City of Ramsey
Agenda
Environmental Policy Board (EPB)
Monday, June 12, 2023
6:30 pm
Council Chambers, 7550 Sunwood Drive NW

Consider Natural Resources Aspects of Proposed Site Plan for Aldi (Project No. 23-105)

Consider Natural Resources Aspects of Proposed Site Plan and Plat for Bunker Lake Industrial Park (Project No. 23-106); Case of PSD, LLC

SITE PLAN

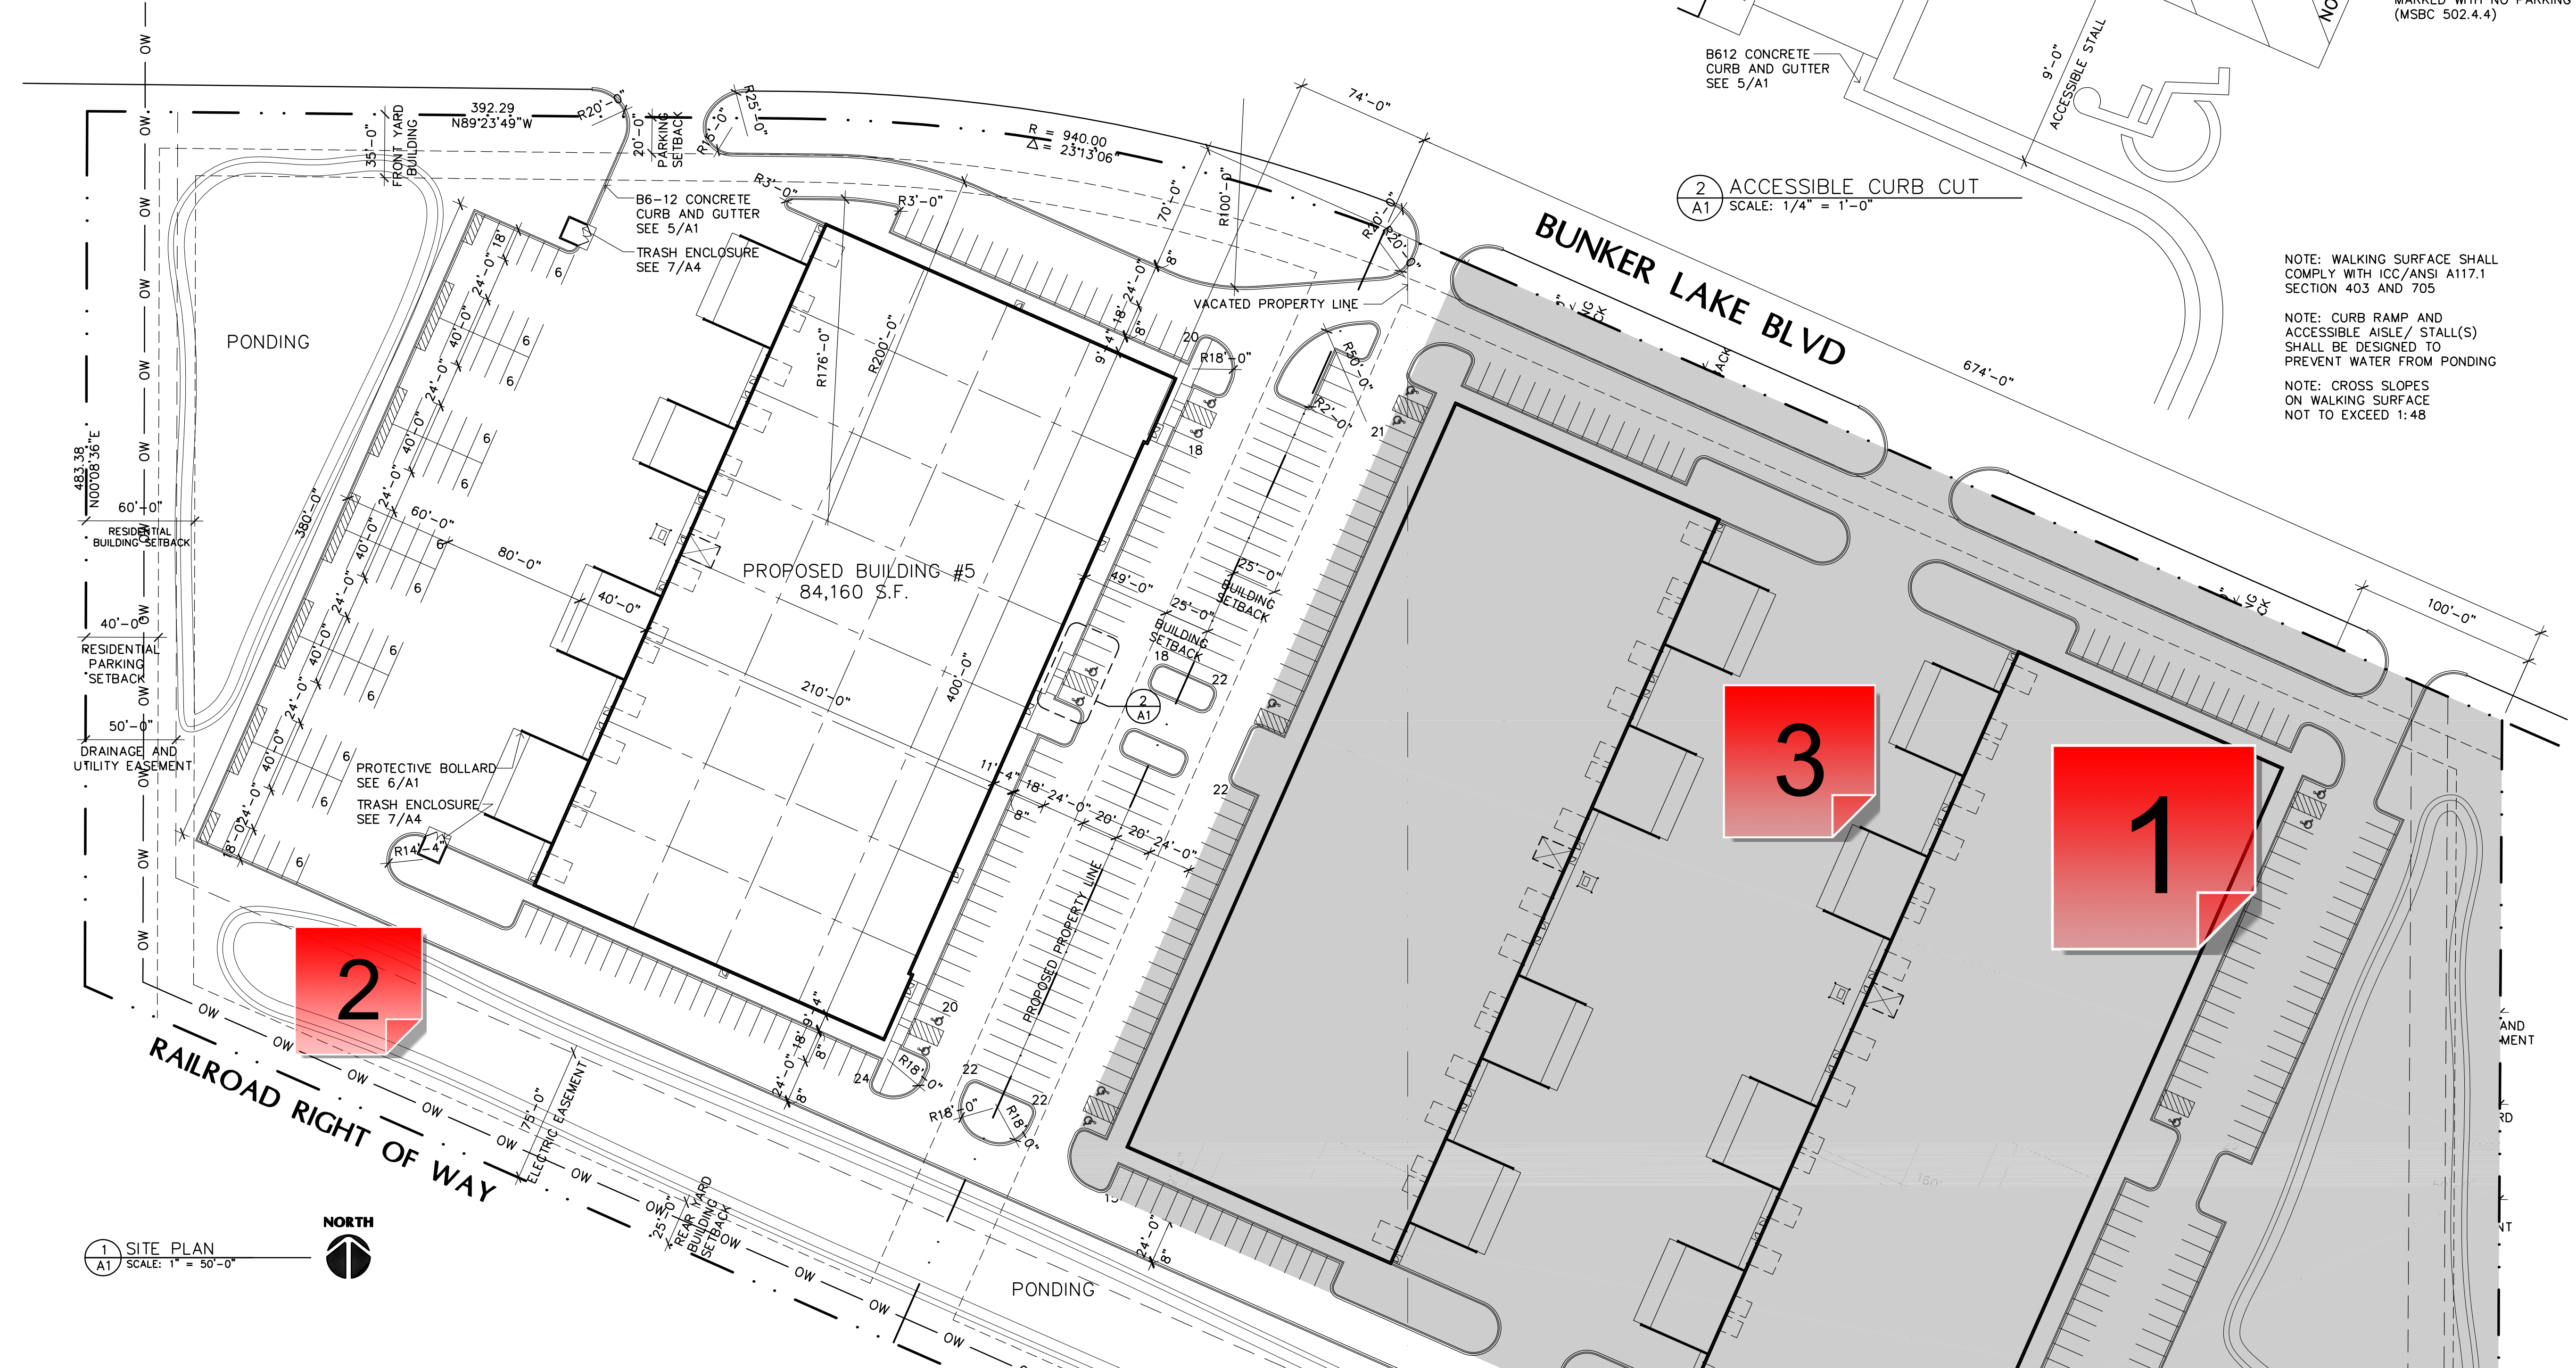
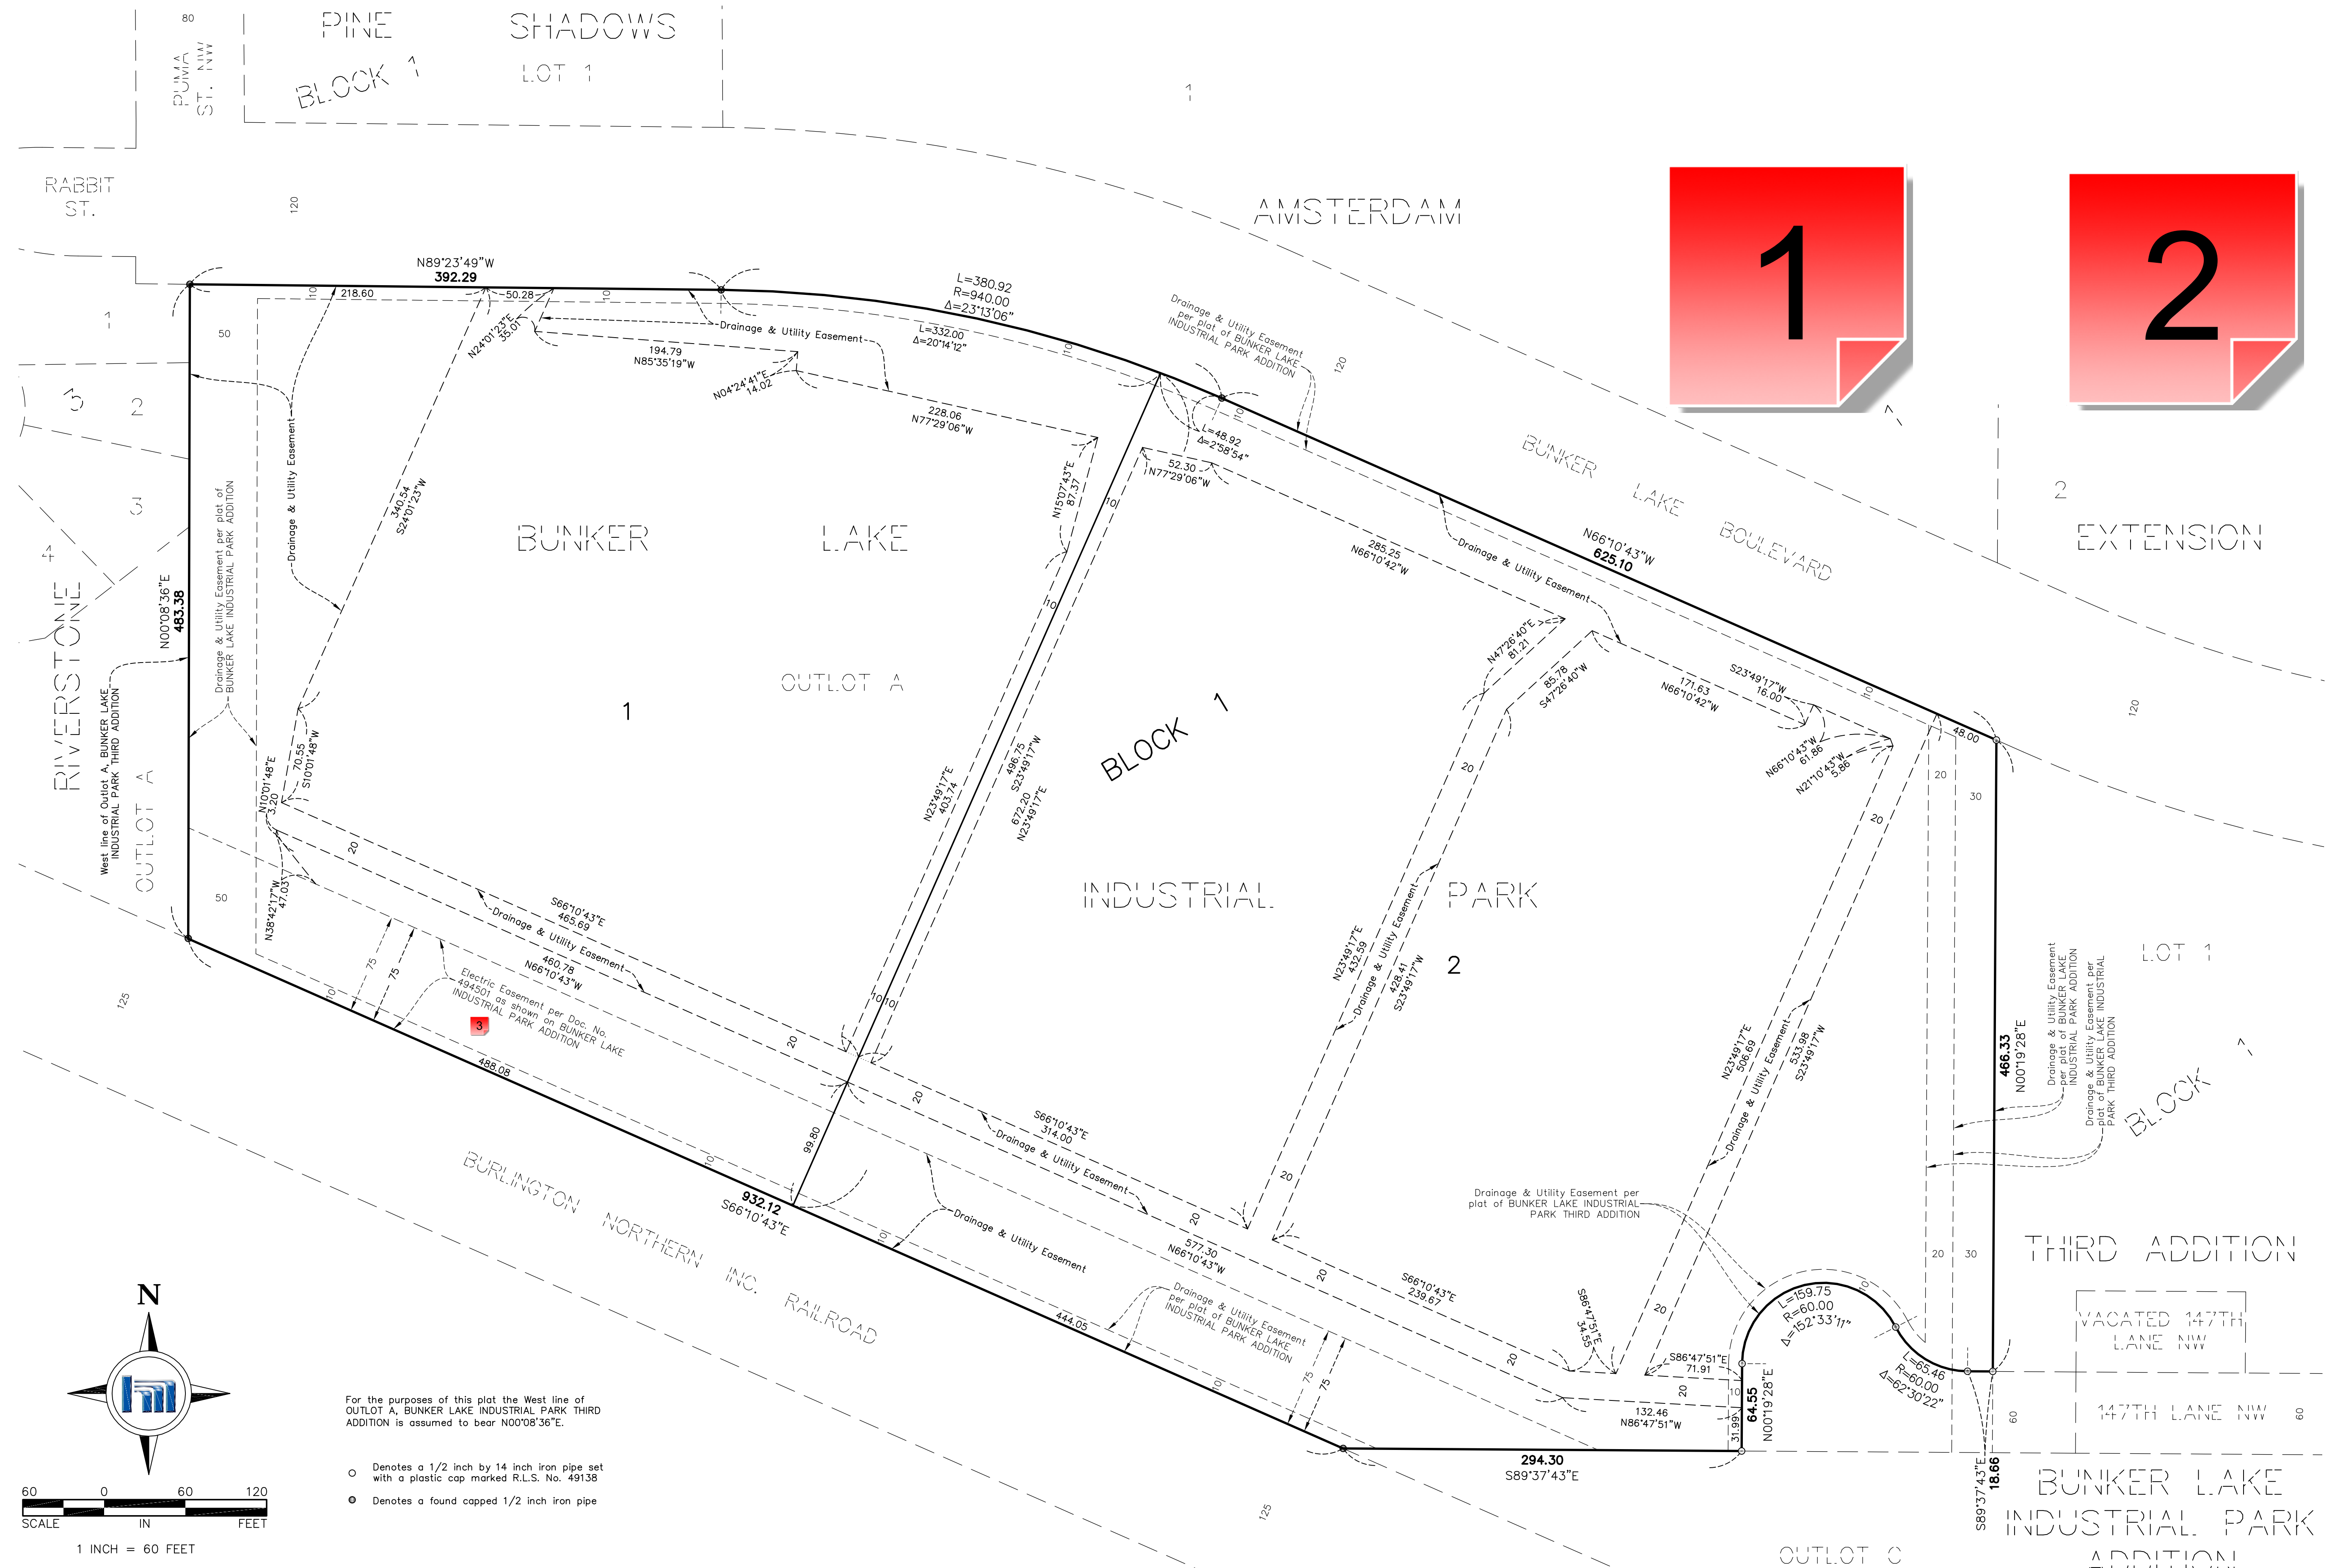
Please provide the proposed square footages for all 3 buildings.

Need to provide the City was documentation showing that the easement holder of the 75' wide electric easement approves locating the ponding within their easement.

Put these details on a separate page so that the entirety of the site improvements (all 3 buildings and all 3 lots) can be shown on the Site Plan sheet.

CITY OF RAMSEY
 COUNTY OF ANOKA
 SEC. 29, T. 32, R. 25

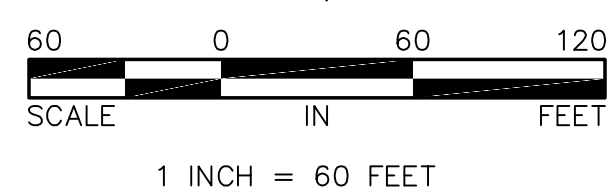
Provide a cross access easement (legal description and exhibit) for the shared 'truck lane' between the two eastern buildings.

Verify the electric easement gives authority to build a pond.

OVERALL LANDSCAPE PLAN
 CITY OF RAMSEY, MINNESOTA

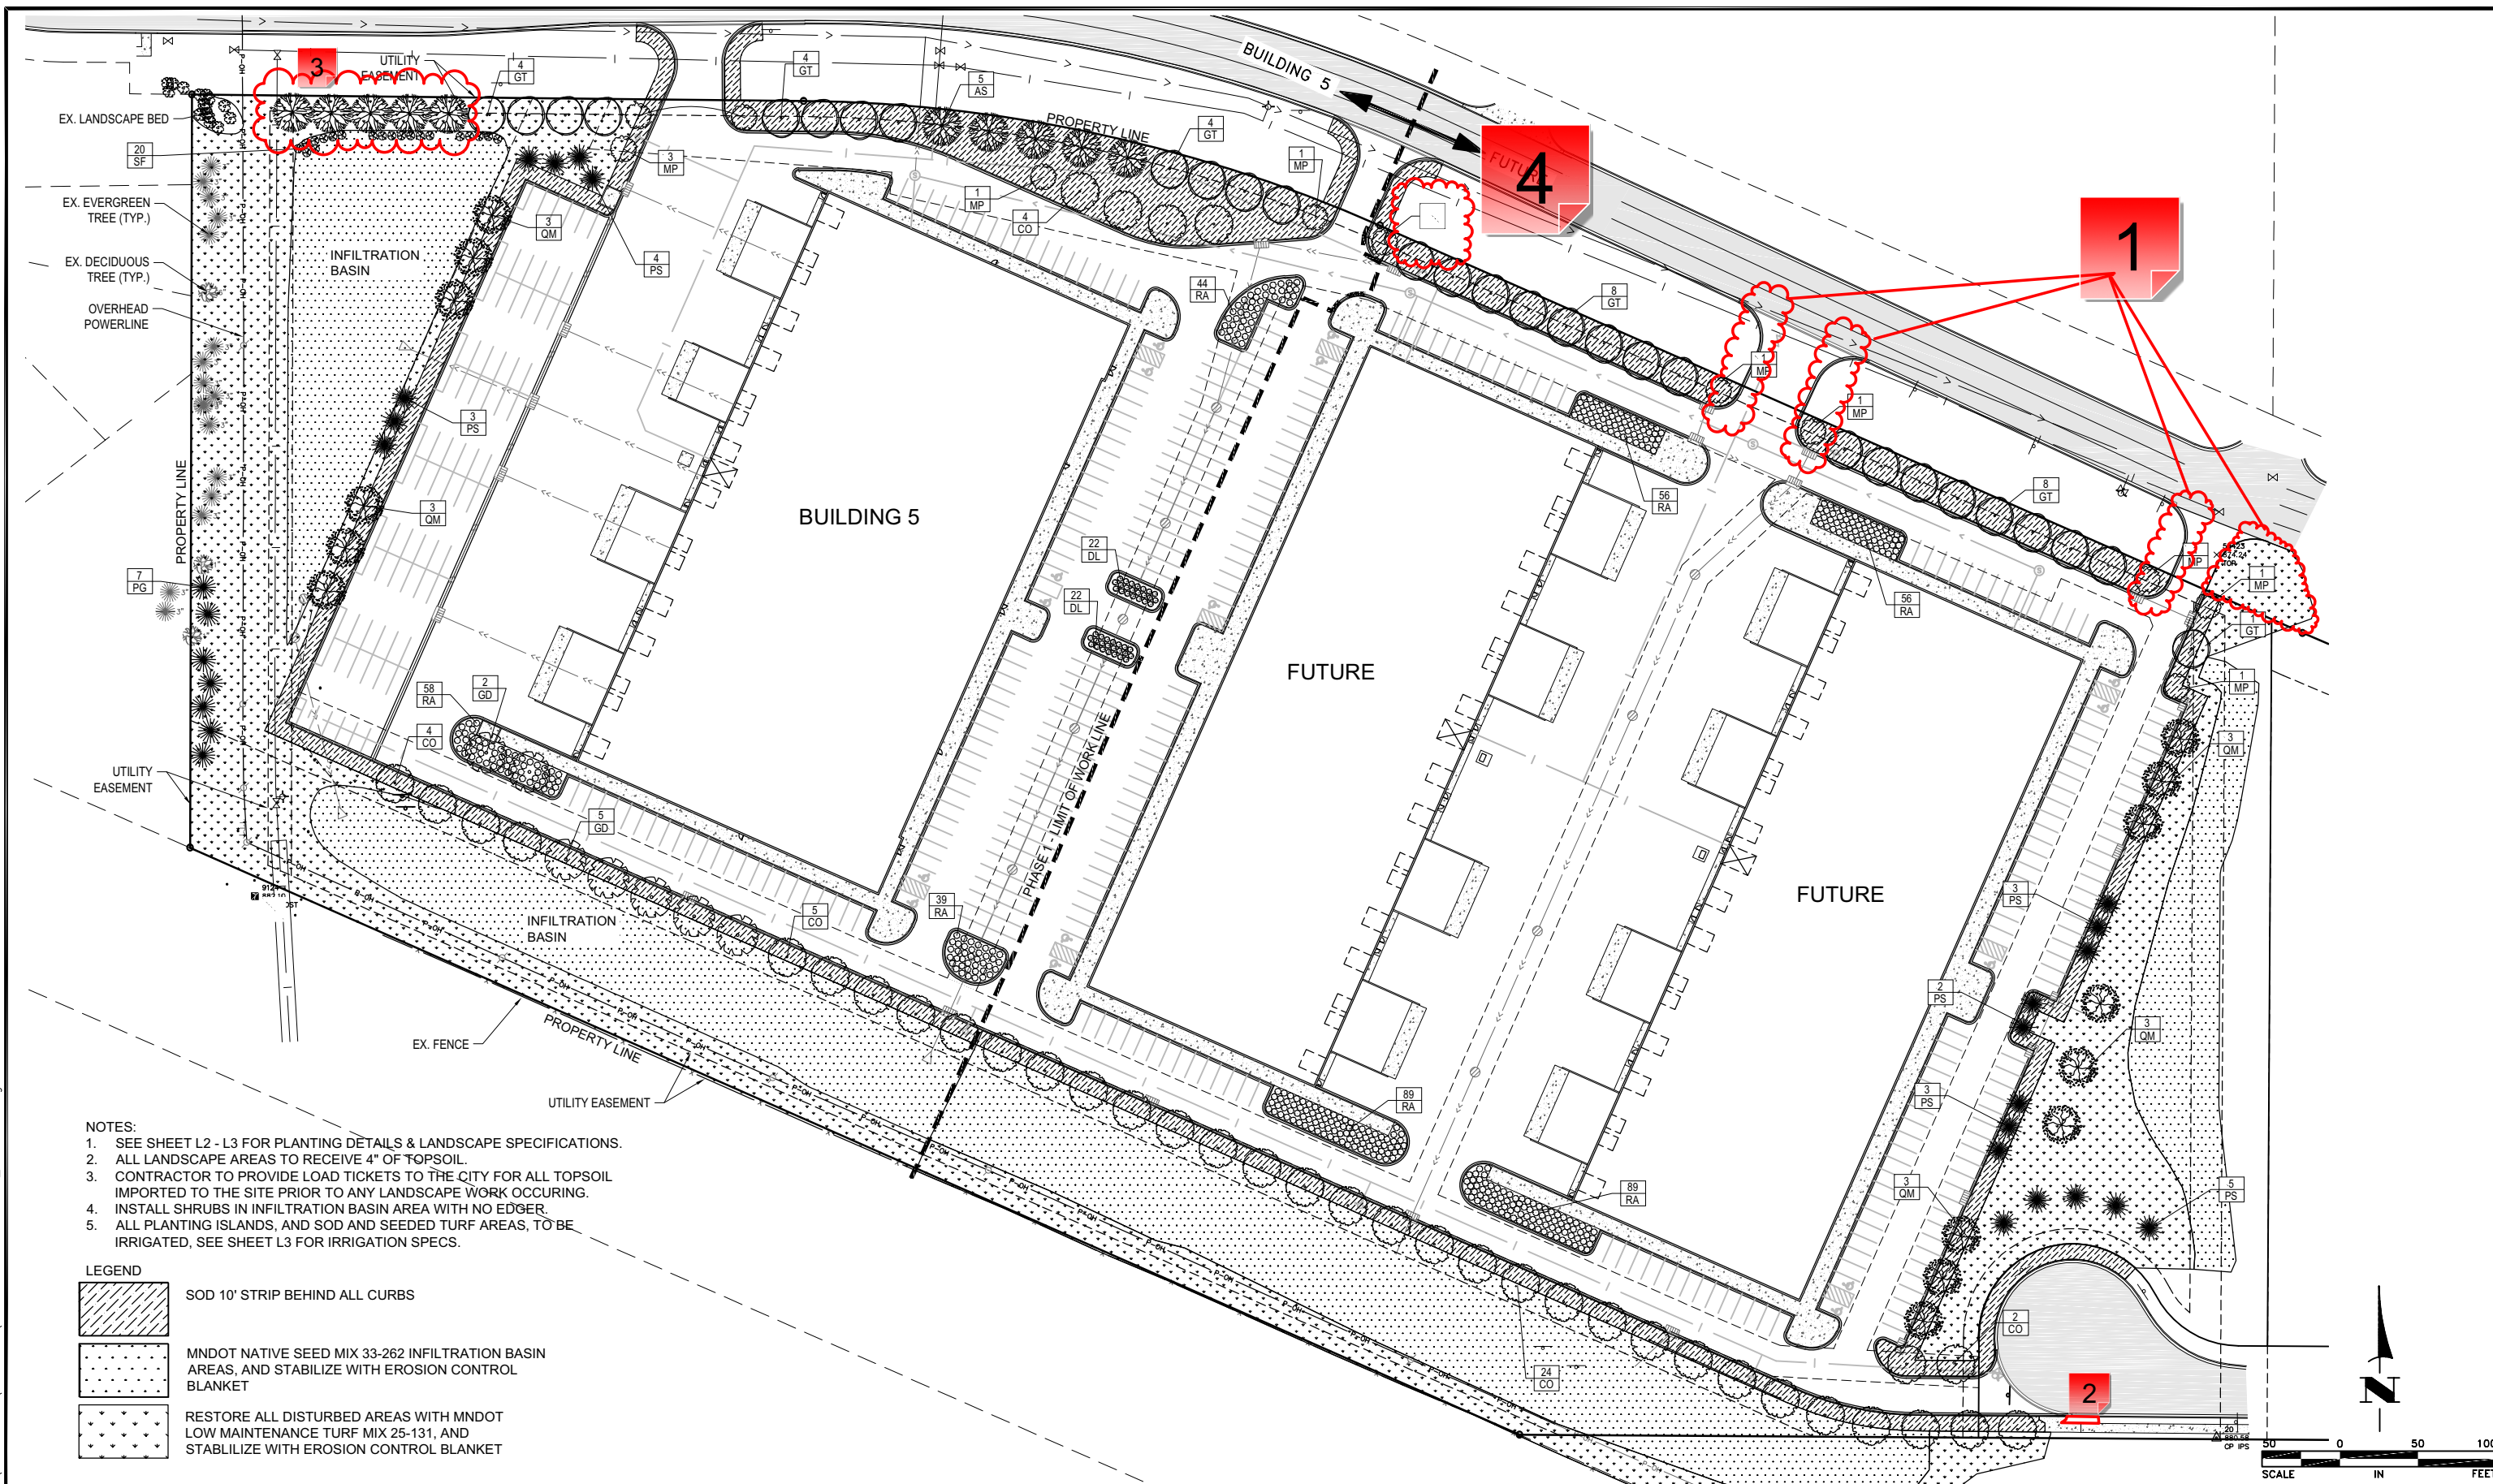
Please add what the species is of these trees.

Add species label or code.

All trees were removed from the BLIP land prior to any site improvements. Owner was informed that throughout the development of the entire BLIP site, reforestation and/or restitution was going to be required to comply with City Code. Staff has added a memo into the documents folder that outlines what will be required to meet those standards (since this is the last of the BLIP land).
